**EVALUATION OF THE ADS TRANSIENT IN
THE AP1000 DESIGN WITH A ONE NODE
DEPRESSURIZATION ANALYSIS (ONDA)**

**ACRS Combined T/H and
Future Plant Design Sub-Committees**

AP1000 Pre-Certification Review
Presentation to the
Advisory Committee on Reactor Safeguards
Combined Thermal-Hydraulic Phenomena /
Future Plant Designs Subcommittee Meeting

EFFECT OF x_{AF}

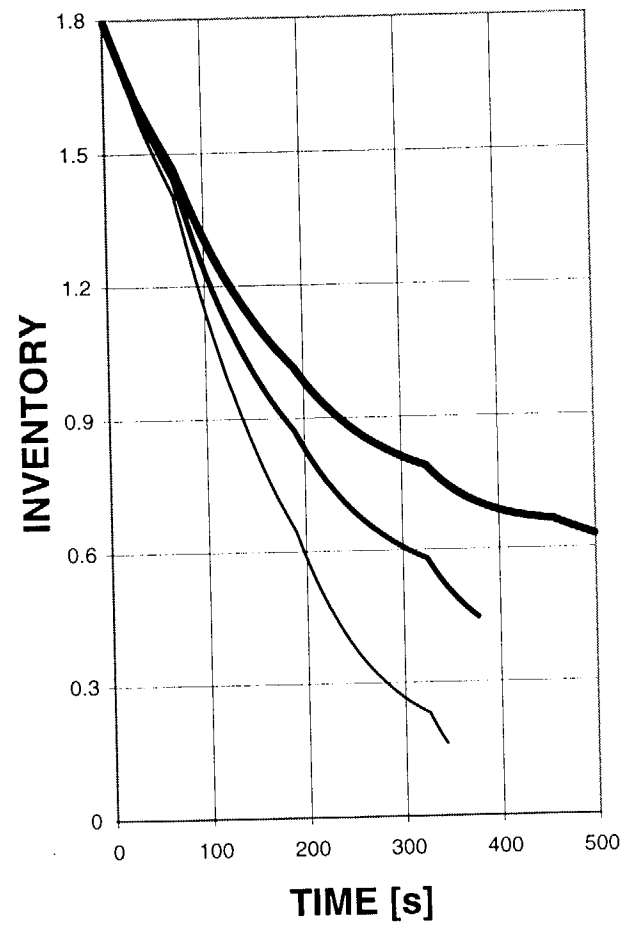
10 What if the quality of the ADS-4 is
11 different? What is the impact of that on the figure
12 of merit?

13 Now, this is very deceiving because of you
14 look at the pressure trace, and you compare the
15 pressure traces for different qualities, they
16 basically are the same curve. They're not going to
17 change much, and this is due to the competing effect.

18 It took me a while to figure it out, but
19 basically what happens here is that if you were to
20 decrease the quality, your pressure stays aloft more
21 in the initial part because you lose liquid rather
22 than vapor. But then you have lost basically all of
23 the liquid. So basically your stored heat goes down
24 the drain.

4 But if you look at inventory, meaning how
5 much shorter you are left with for injection, that's
6 a completely different answer. There there is a
7 tremendous impact.

- The pressure behavior of the AP1000 for decreasing quality of the ADS discharge is quite complex. There are two of phenomena that compete with each other:
 1. A lower quality of the ADS discharge flow affects the heat removal and therefore decreases dp/dt early on
 2. Later in the transient, the residual system compliance increases dp/dt since the residual inventory is significantly reduced for lower qualities of the ADS discharge

Process	Scaling Parameters	Conclusion
Hot leg flow regime transition	Fr_m	Acceptable
Cold leg flow regime transition	Fr_m	Acceptable
Flooding	Ku	Acceptable
Core exit void fraction	α	Acceptable
Hot leg entrainment	(h_b/D) $J_{g,onset}$	Distorted
Upper plenum pool entrainment	E_{fg}	Distorted

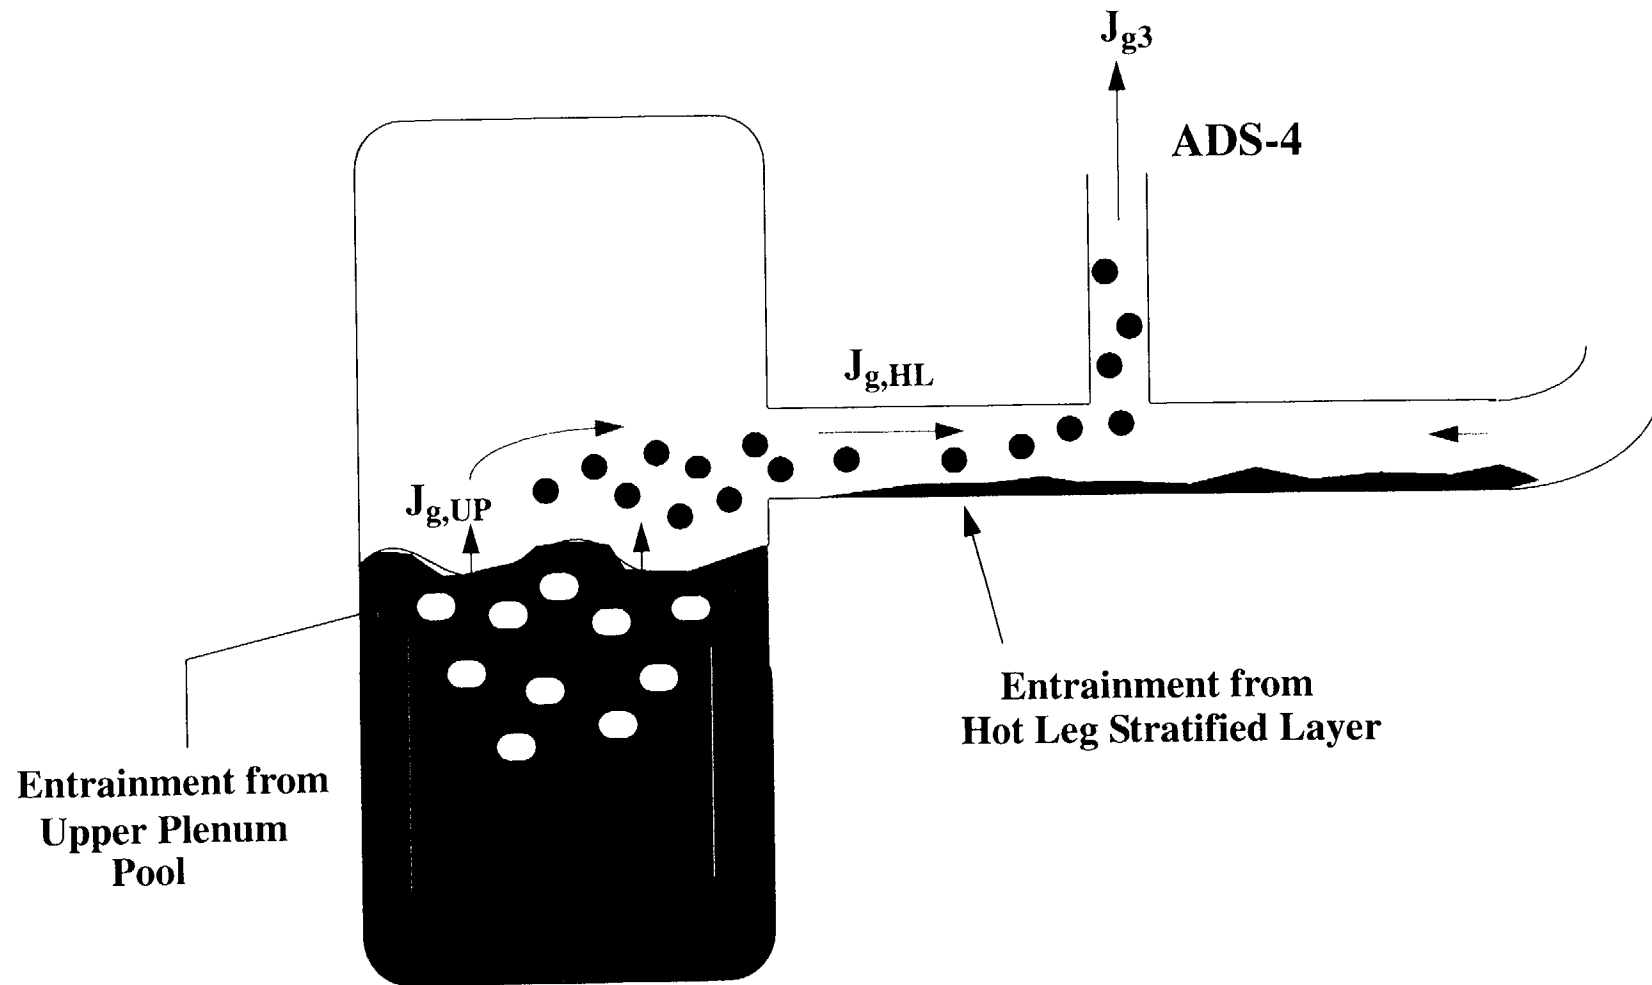
3 Our conclusion at this point is that
4 Westinghouse has not demonstrated that those processes
5 were adequately present in the test facilities for the
6 range of conditions that would apply to the AP 1000.
7 So we're saying for Phase 3 this is something that we
8 have to investigate in more detail.

Figure A. Expected hot leg flow patterns in IRWST Injection period.

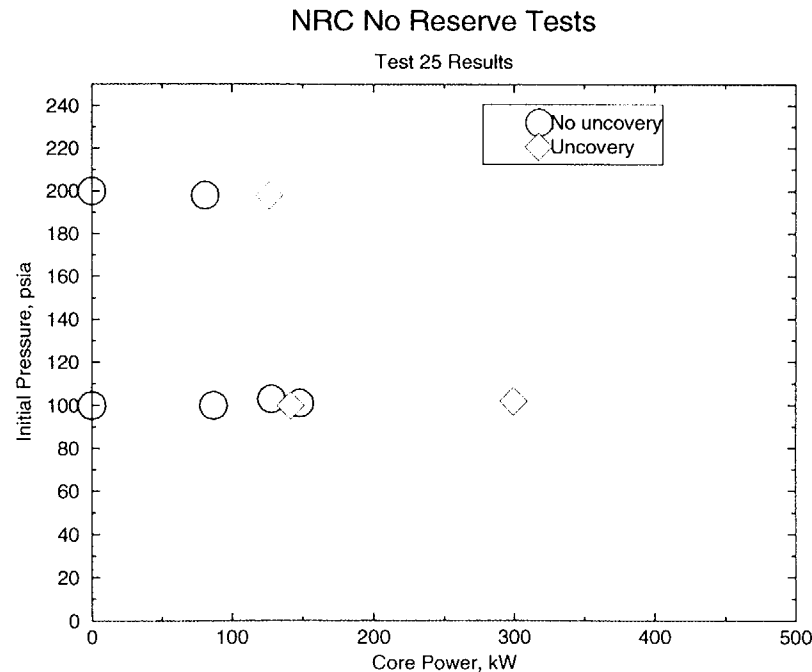
- ◆ Hot leg entrainment expected for AP1000, but not for AP600 or IETs.

◆ **Conclusions for Hot Leg Entrainment:**

Liquid Entrainment Scaling

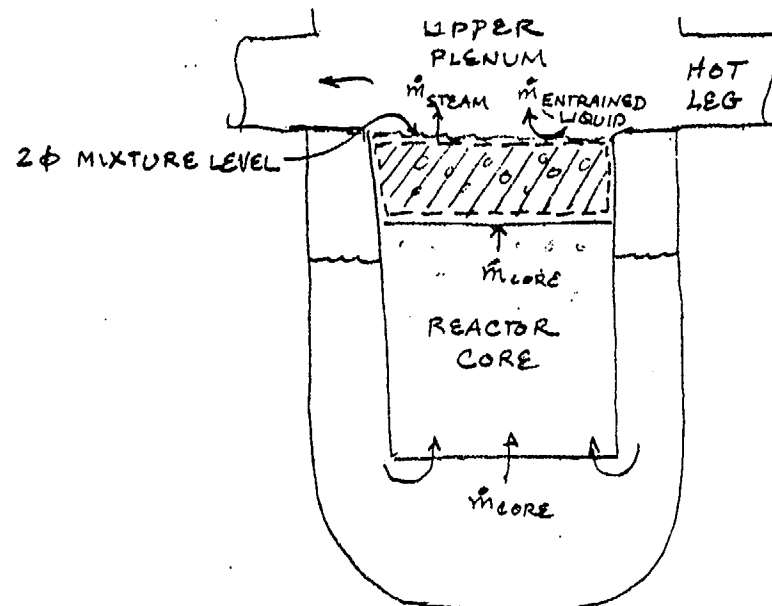
5 So where it doesn't have the correct J sub
6 g, it makes up for that because there's less height
7 you have to carry fluid out of the upper plenum. We
8 might call this a compensating error if we look at how
9 much time it would take to train the facility. It is
10 saying that Apex may not be unusable.

Sump Injection Phase - Hot Leg Horizontal Flow Regime Map (Taitel-Dukler)

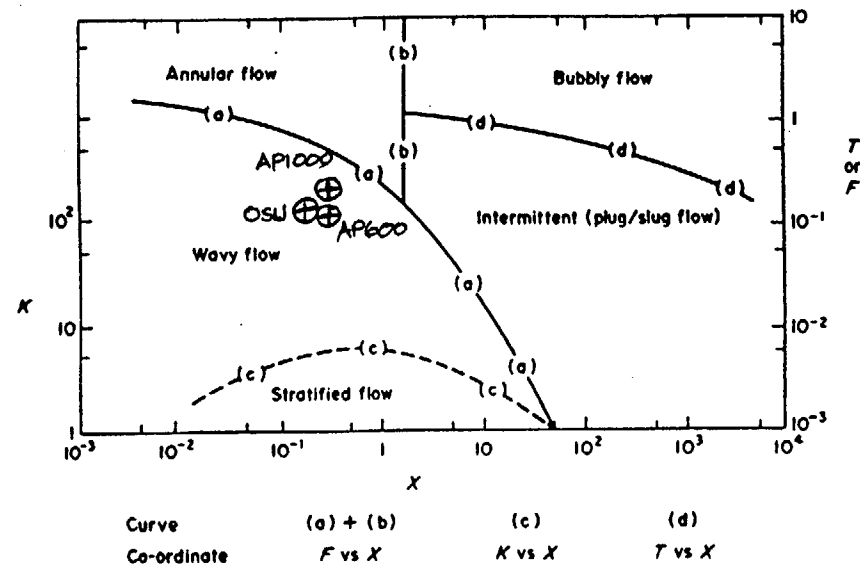
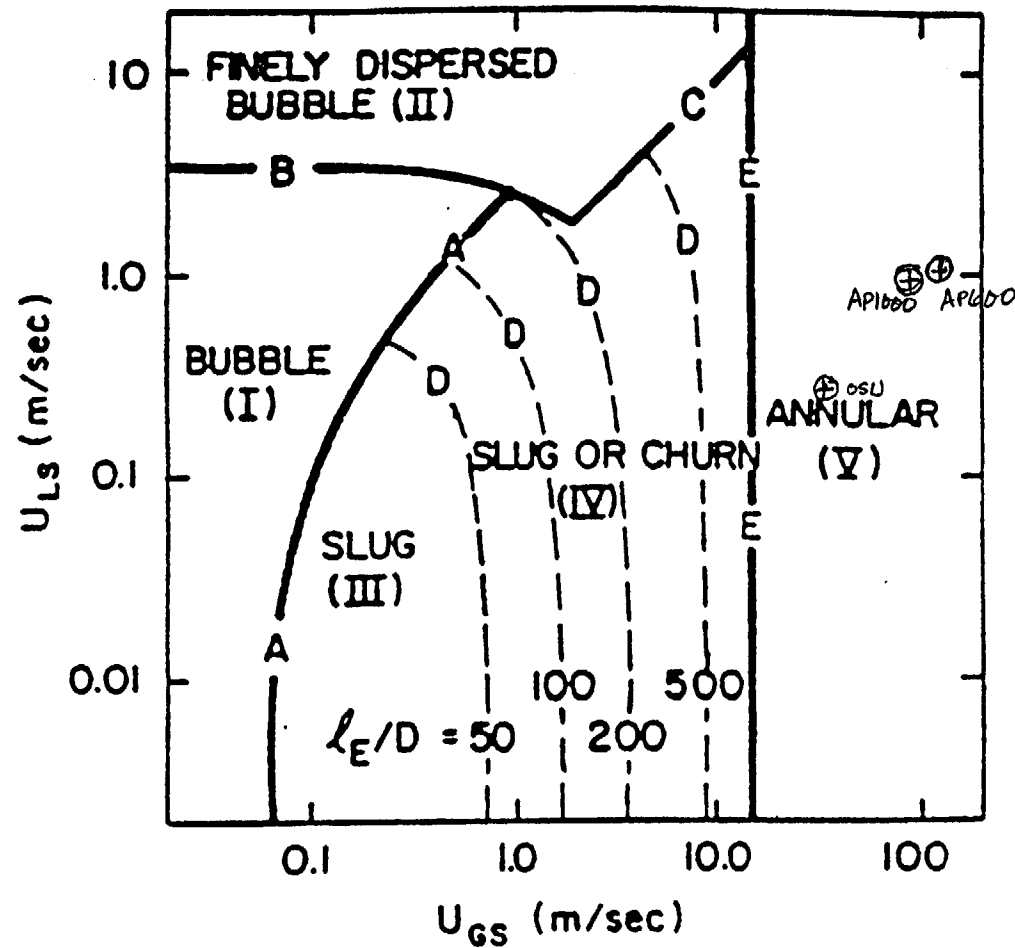
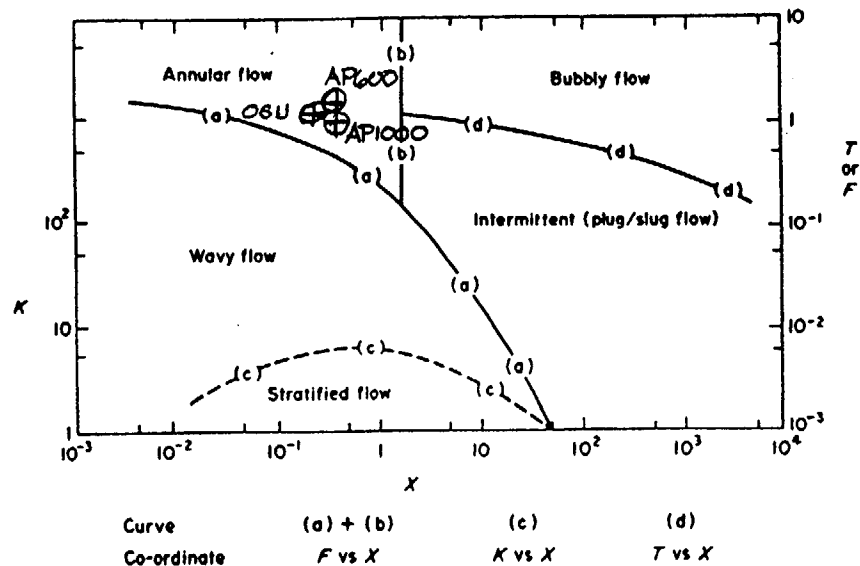
- Dr. Wallis commented on flow regime in vent path and use of homogeneous model for scaling two-phase natural circulation at 3/15/01 ACRS T/H subcommittee meeting. At low pressure, such as during sump injection, slip between liquid and vapor phases is significant.
- Flow regime maps for vent path (hot leg and ADS4 piping) during sump injection phase generated.
- Separated flow model used to scale core exit quality during sump injection phase.

Sump Injection Phase - Flow Regime Conclusions
